ADMINISTRATIVE SITE PLAN & MODIFICATIONS REPORT AND DECISION

Project Name: My Dental Office Building

File Number: LUA15-000729, SA-A, MOD, MOD, LC

SITE PLAN
 Scale: 3/16"=1'-0"
 Sheet Number

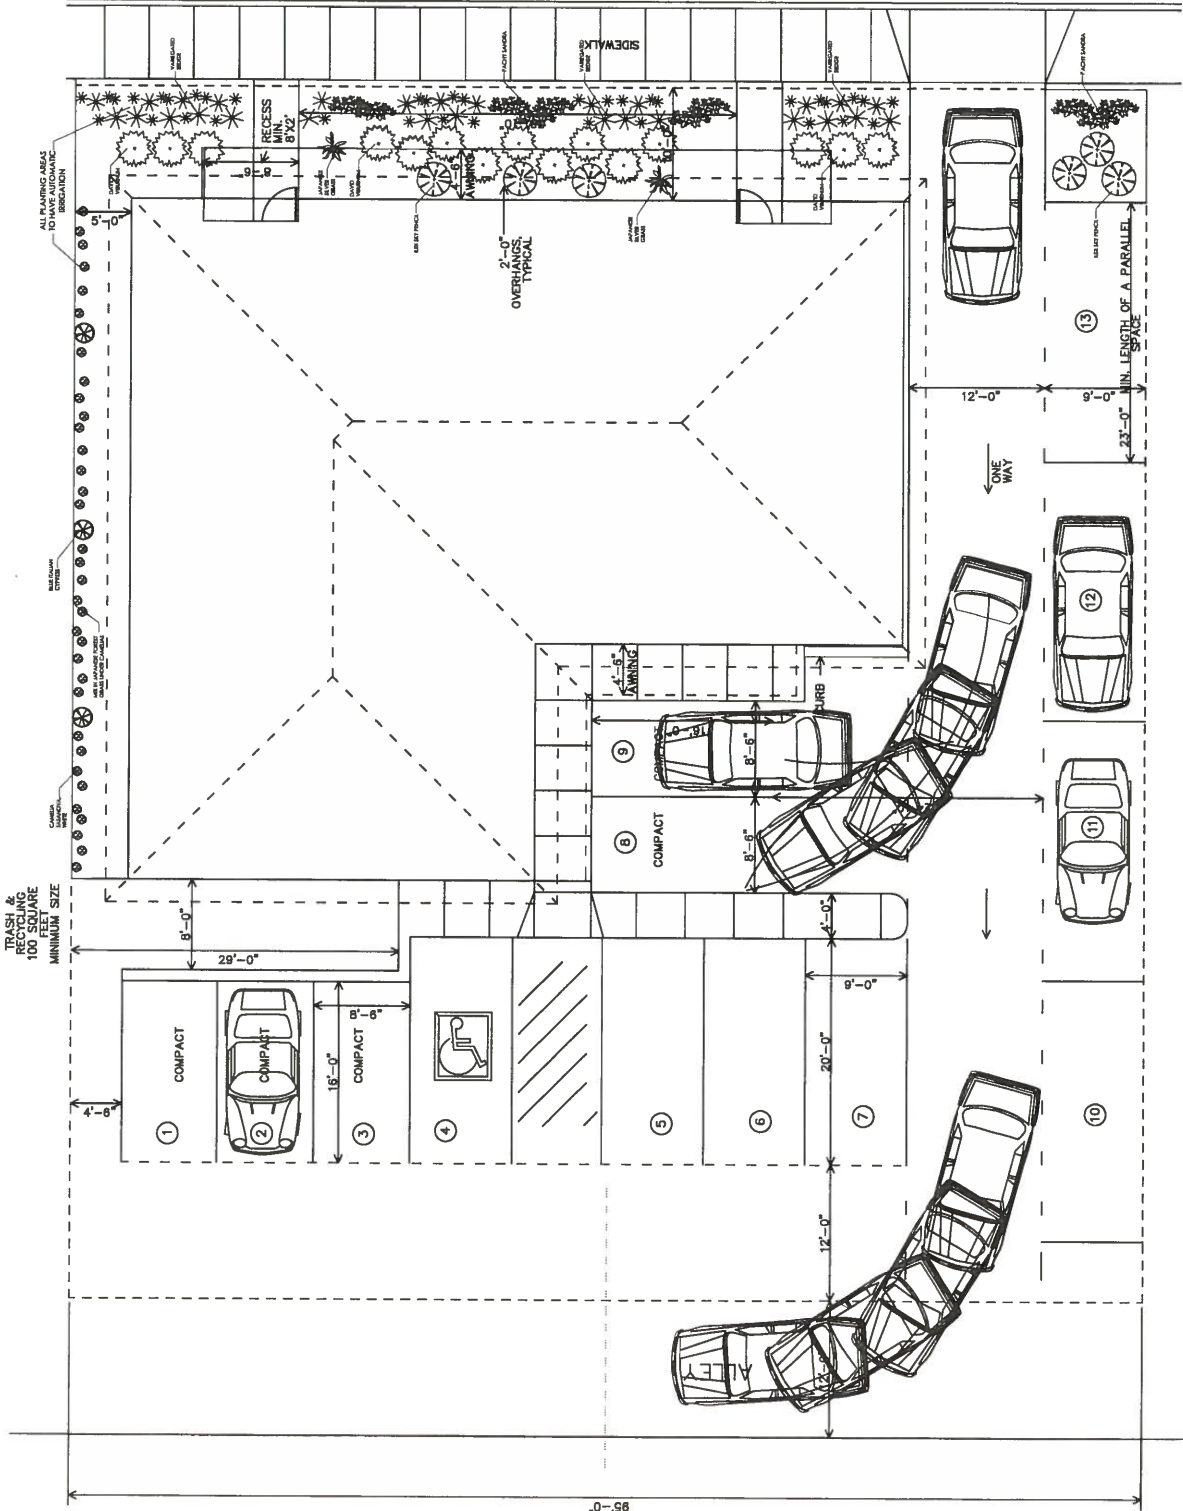
11. The applicant requests that the front yard setback for the proposed building under RMC 4-2-120A "Minimum Front Yard Setbacks" be reduced to less than 10 feet. The proposal is a front yard setback of approximately 6 inches for the building as allowed through Site Plan review for the CA zone (Exhibit 5).

Compliant if condition of approval is met	<p>Setbacks: Per RMC 4-2-120A the CA zoning classification requires a minimum front yard, and side yard along-a-street setback of 10 feet which may be reduced to zero feet during the site plan development review process, provided blank walls are not located within the reduced setback. There is a maximum front yard setback of 15 feet. The CA zone has no rear or side yard setback except 15 feet if lot abuts or is adjacent to a residential zone.</p> <p><i>Staff Comment:</i> The proposed building has an approximate 6 inch front yard setback from the proposed Park Ave N boundary following the proposed dedication of right-of-</p>

way (Exhibit 5). The existing Park Ave N right-of-way line would be relocated to the west approximately 9 ½ feet following the proposed dedication. The applicant is requesting Administrative consideration for less than the minimum 10-foot front yard setback as allowed in the CA zone. An applicant can make this request through the Site Plan Review process if blank walls are not located within the proposed reduced setback area. Analysis of blank walls and recommendation of the lesser setback than 10 feet is provided below in this report subsection following analysis of the proposed setbacks.

The submitted site plan and building elevations identify roof overhangs extending out 2-feet from all facades (Exhibit 5 and 9). The east facing building façade would be approximately 6 inches from the new right-of-way and the 2-foot roof overhang would project approximately 1 ½ feet into the right-of-way. Building roofs are not allowed to project into public right-of-way areas. Per RMC 4-2-120F.5.b, eaves and roof overhangs are allowed to project up to 2 feet into a private yard setback but not public right-of-way area. The proposed roof projection would not be allowed as designed. Awnings and similar overhangs that are connected to the side of a wall, and not the permanent roof, are allowed to project into the right-of-way. Therefore, staff recommends a condition of approval that the roof overhang along the Park Ave N facade be revised with a shorter roof overhang, building footprint change, or other alternative that would not have a roof within the proposed right-of-way area. The revised elevations or plans shall be submitted to the Current Planning Manager, for review and approval, prior to building permit approval or construction permit approval whichever comes first.

The applicant has designed the building to provide a 35-foot rear setback from the alley to the west following the proposed 2 feet of right-of-way dedication (Exhibit 5).

Staff Comment: A minimum and maximum of 12 vehicle parking stalls is required for the dental offices proposal based on the table above. The applicant proposes 13 parking stalls in total with the majority behind the building at the rear of the site and a row of three parallel parking stalls along the southern boundary. The thirteenth stall beyond the 12 maximum increases the amount stalls by approximately 8 percent.

Sheet Number: **A5.0**

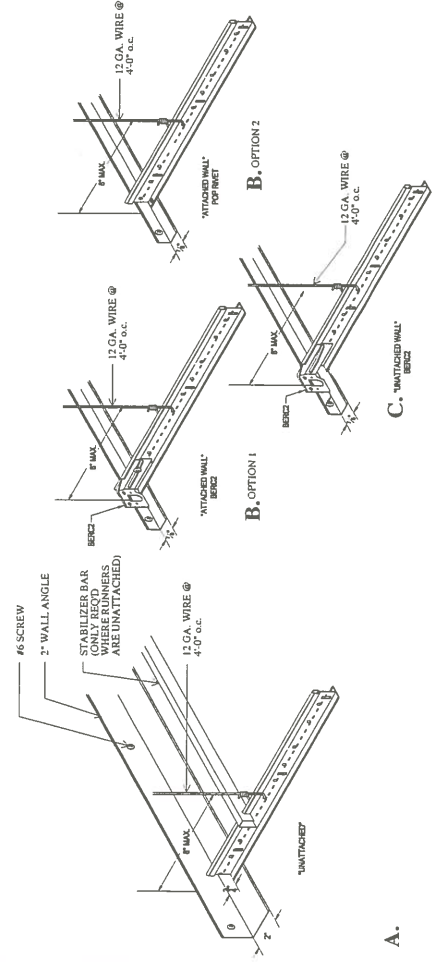
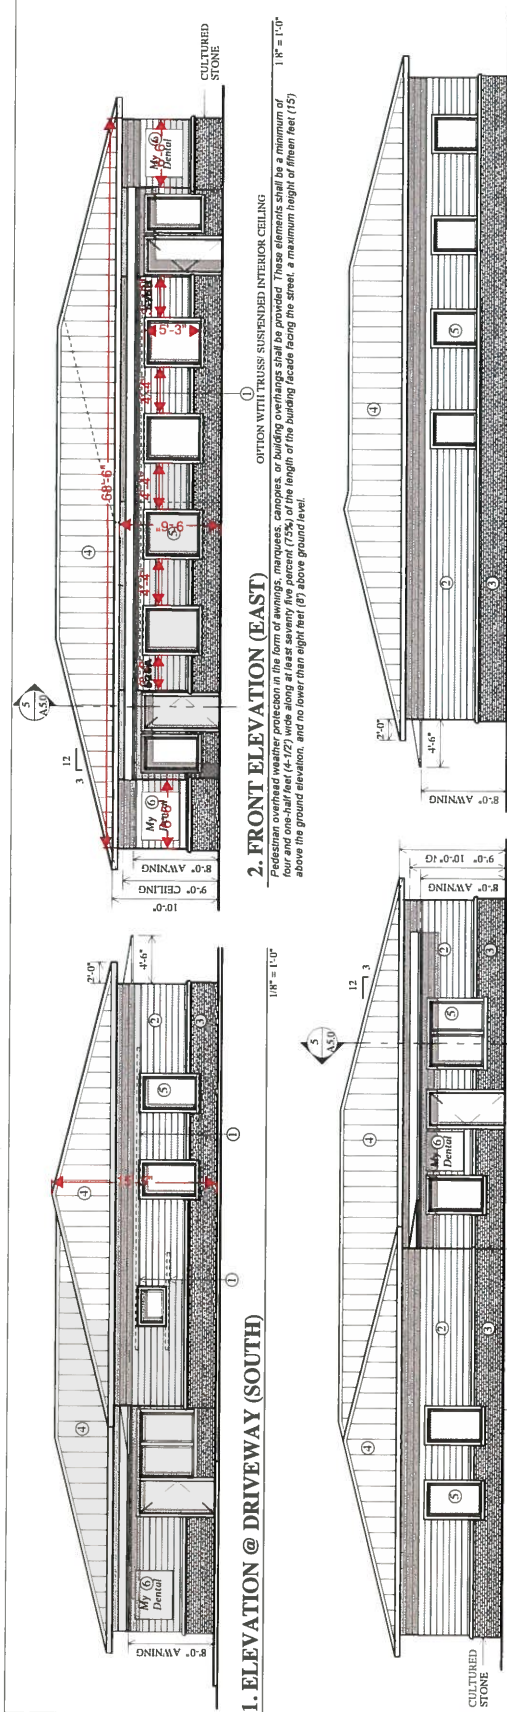
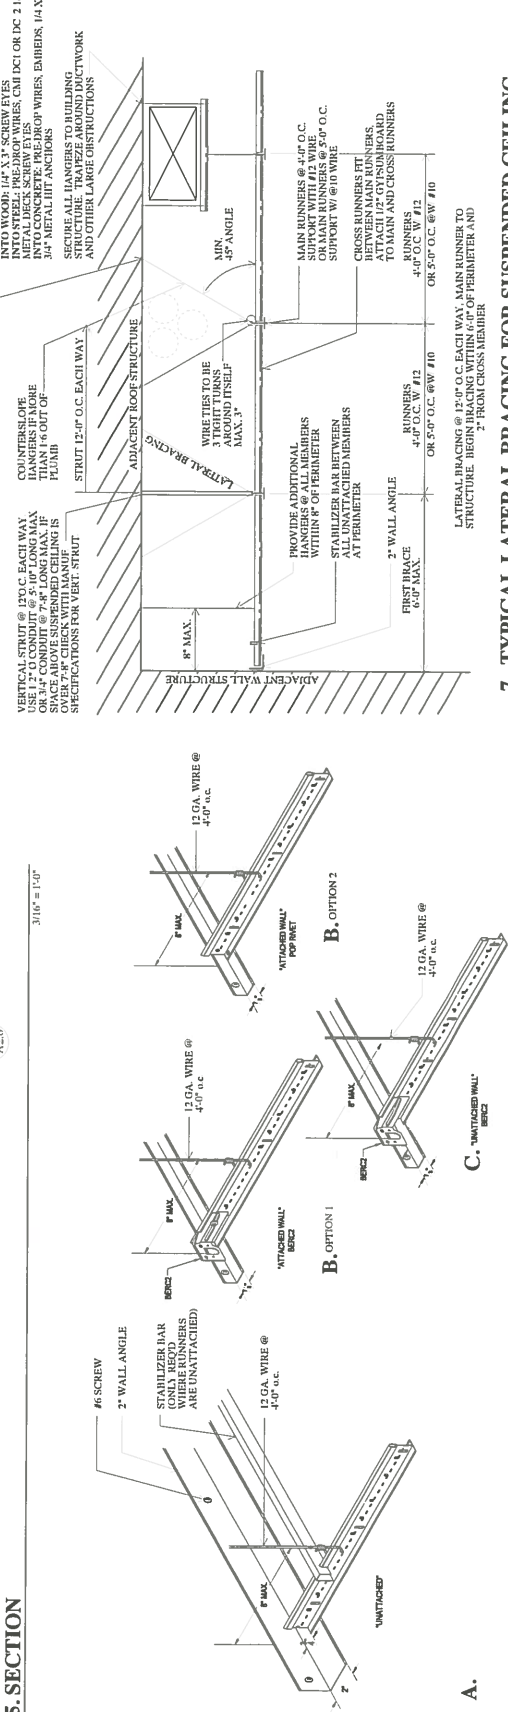
<p>Staff Comment: Staff's following analysis finds that the proposed front façade facing east is not considered a blank wall. The proposed length of the east façade is approximately 68 ½ feet (Exhibit 9). The majority of the façade consists of glass windows and glass entry doors at the two office entries. Based on staff measurements, there are no distances between windows and/or entry doors greater than 6 ½ feet without modulation, window, doors, or other architectural detailing (Exhibit 9). Additionally there are no blank surface areas of 400 sf or greater along the east façade as designed. Although there are no blank walls or blank areas identified by the staff analysis, staff recommends conditions of approval later in the report, FOF 25 Design Standards and Design District Review, to revise the front façade primary entries to incorporate more architectural features. Therefore, staff supports the proposed reduction in the front yard setback from 10 feet to 6 inches on the east facing front façade if all conditions of approval of this report are met including revisions of the primary entries and revision of the roof overhang. The proposal complies with all other setback requirements of the zone.</p>

<p>height, and eight feet (8') in width.</p> <p><i>Staff Comment: The two modulations on the east façade are 2 feet deep and 8 feet in width where the two office entries are located. The single-story roofline begins at 10 feet above the sidewalk. The building does not have a 16-foot tall façade. The building modulations at the entries extend from the ground level to the roofline and therefore, the full height of the building's façade, which meets the intent of the modulation height requirement. See comments above addressing modulation on the north façade.</i></p>
N/A	<p>Standard: Buildings greater than one hundred sixty feet (160') in length shall provide a variety of modulations and articulations to reduce the apparent bulk and scale of the facade; or provide an additional special feature such as a clock tower, courtyard, fountain, or public gathering area.</p>
<p>2. Ground-Level Details:</p> <p>Intent: To ensure that buildings are visually interesting and reinforce the intended human-scale character of the pedestrian environment; and ensure that all sides of a building within near or distant public view have visual interest.</p> <p>Guidelines: The use of material variations such as colors, brick, shingles, stucco, and horizontal wood siding is encouraged. The primary building entrance should be made visibly prominent by incorporating architectural features such as a facade overhang, trellis, large entry doors, and/or ornamental lighting (illustration below). Detail features should also be used, to include things such as decorative entry paving, street furniture (benches, etc.), and/or public art.</p>

Compliant if condition of approval is met	<p>Standard: Human-scaled elements such as a lighting fixture, trellis, or other landscape feature shall be provided along the facade's ground floor.</p> <p><i>Staff Comment: The proposed elevations have a minimal amount of human-scaled elements. All entries are covered by awnings but the only other human-scale element other than windows, and doors is a landscape strip along the front façade. Staff has recommended multiple conditions of approval to increase human-scaled elements along the front façade and an increase in architectural design around front entries. With the staff recommended conditions of approval, staff will review future revisions of the building facades and anticipates that additional human-scale elements will be provided beyond the current proposal if all condition of approval are complied with.</i></p>
✓	<p>Standard: On any facade visible to the public, transparent windows and/or doors are required to comprise at least 50 percent of the portion of the ground floor facade that is between 4 feet and 8 feet above ground (as measured on the true elevation).</p> <p><i>Staff Comment: Staff's evaluation below finds that the east facing public façade along Park Ave N is comprised of at least 50 percent transparent windows/doors. The length of the façade along Park Ave N is approximately 68-1/2 feet. Between 4 and 8 feet in height along the façade, approximately 56 percent of the façade has window or door treatments (Exhibit 9).</i></p>

MODIFICATION

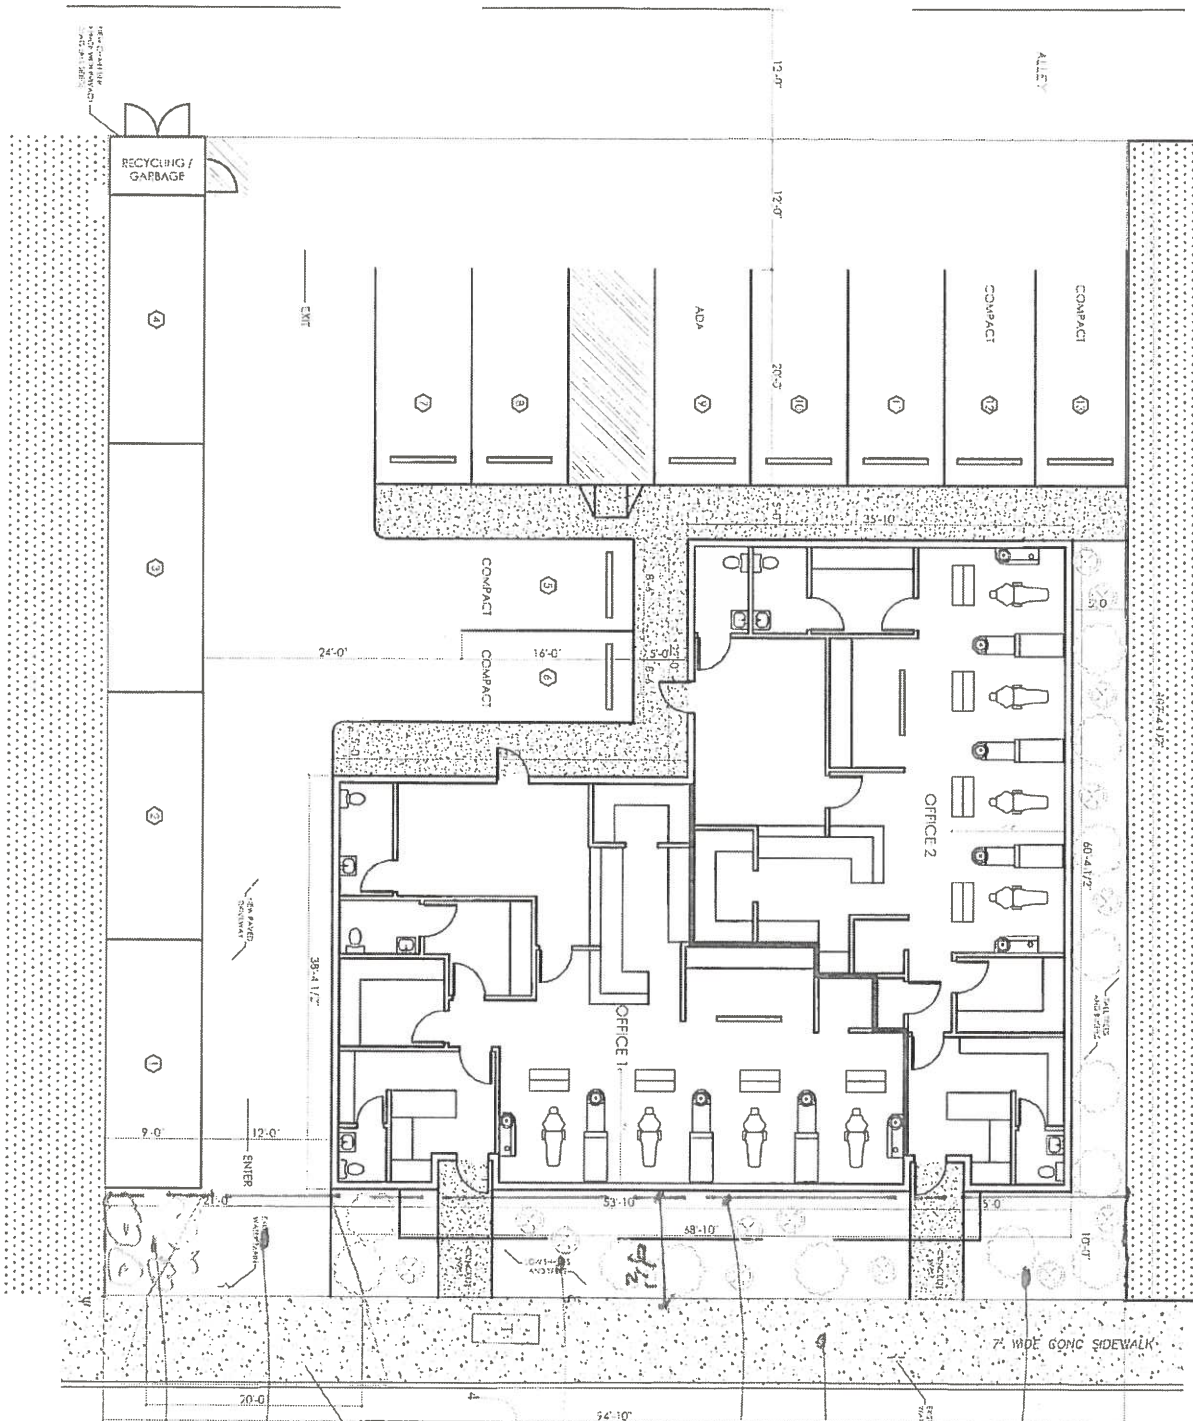
10. The applicant requests two Modifications for allowances from the City's street and driveway standards. The Street Modification from RMC 4-6-060F.2 is requested to leave the existing right-of-way improvements along Park Ave N rather than install new improvements including new sidewalk and planter strip. The Driveway Modification from RMC 4-4-080I.4 is requested to allow two driveway curb cuts along Park Ave N for contiguous properties under the same ownership (Exhibits 10 and 11).

<p>sound engineering judgment.</p> <p><u>Staff Comment:</u> The modified street improvements will meet the objectives of a safe walkable environment as intended by the code. The improvements provide for a planting strip of sufficient size for landscaping on the backside of the sidewalk. The seven foot wide sidewalk at this location meets the needs of the residents relying on this sidewalk for access to the greater neighborhood.</p>
✓	<p>c. Will not be injurious to other property(ies) in the vicinity.</p> <p><u>Staff Comment:</u> The improvements will provide an upgrade to current conditions. The new improvements will meet the standards for safe vehicular and pedestrian use within the current roadway improvements and would not be injurious to other properties in the vicinity</p>
✓	<p>d. Conforms to the intent and purpose of the Code.</p> <p><u>Staff Comment:</u> See comments under criterion 'b'.</p>
